UNITED STATES PATENT AND TRADEMARK OFFICE

Office Action Summary	Application No. 10/551,363	Applicant(s) DOWNEY, EARL C.
	Examiner JENNIFER L. HORNBERGER	Art Unit 3734

DETAILED ACTION

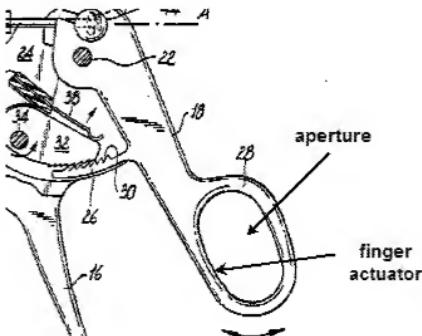
Regarding claim 1, Cuny et al. disclose a surgical device, comprising: an ergonomic handle (16) having an aperture accessible by a single finger of a user, and a finger actuator (the inside surface of the aperture on which pressure is applied to actuate movement; see figure below) accessible through the aperture, the finger actuator being sized and shaped to receive a single finger of a user; an elongated tubular portion (14) extending from the ergonomic handle and having a longitudinal axis; and a rod (42) functionally disposed within the tubular portion along the longitudinal axis, the rod being coupled proximally to the finger actuator and configured to be coupled distally to a functional end (46, 48).

Regarding claim 12, Cuny et al. disclose a surgical system operated by a single finger, comprising: an ergonomic handle (16) having an aperture accessible by a single finger of a user, and a finger actuator (the inside surface of the aperture on which pressure is applied to actuate movement; see figure above) accessible through the aperture, the finger actuator being sized and shaped to receive a single finger of a user; an elongated tubular portion (14) extending from the ergonomic handle and having a longitudinal axis, the finger actuator being positioned substantially in line with the longitudinal axis of the tubular portion (at least the top portion of the finger actuator is substantially in line with the longitudinal axis); and a rod (42) functionally disposed within the tubular portion along the longitudinal axis, the rod being coupled

7. Applicant's arguments filed 10/03/2008 have been fully considered but they are not persuasive. With respect to applicant's argument that Cuny et al. fail to disclose an aperture accessible by a single finger of a user, and a finger actuator accessible through the aperture, the finger actuator being sized and shaped to receive a finger of the user. See discussion in rejections of claims 1 and 12 above. The inside surface of the finger ring, which is taken to be the actuator, is accessed by placing a finger through the aperture. The aperture is sized so that it could receive a finger if so desired.

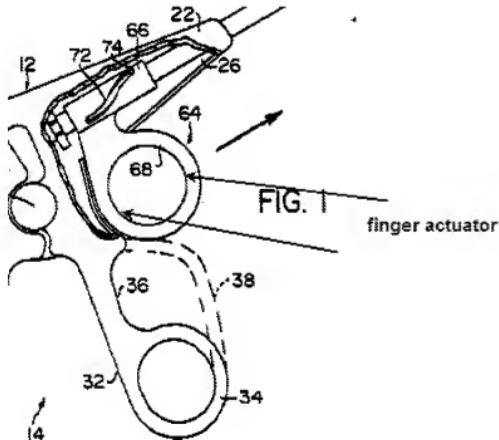
Regarding claim 19, Blake discloses a method of manipulating a surgical instrument with a single finger, comprising the following steps: grasping the surgical instrument with a hand of a user; inserting the single finger of the user into a finger actuator (inside surface of the aperture on which pressure is applied to actuate movement; see figure below) accessible through an aperture (68) of an ergonomic handle of the surgical instrument; moving the single finger in a direction away from the hand, causing operation of a functional end; and moving the single finger in a direction toward the hand, causing operation of the functional end (Figures 1 and 2).

Regarding claim 20, Blake discloses a method of manipulating a surgical instrument with a single finger further comprising the step of rotating the functional end with the single finger (Figures 1 and 2).

8. Regarding applicant's argument that Blake fails to disclose a finger actuator accessible through an aperture of an ergonomic handle, see discussions of claim 19 above. The inside surface of the finger ring, which is taken to be the actuator, is accessed by placing a finger through the aperture.
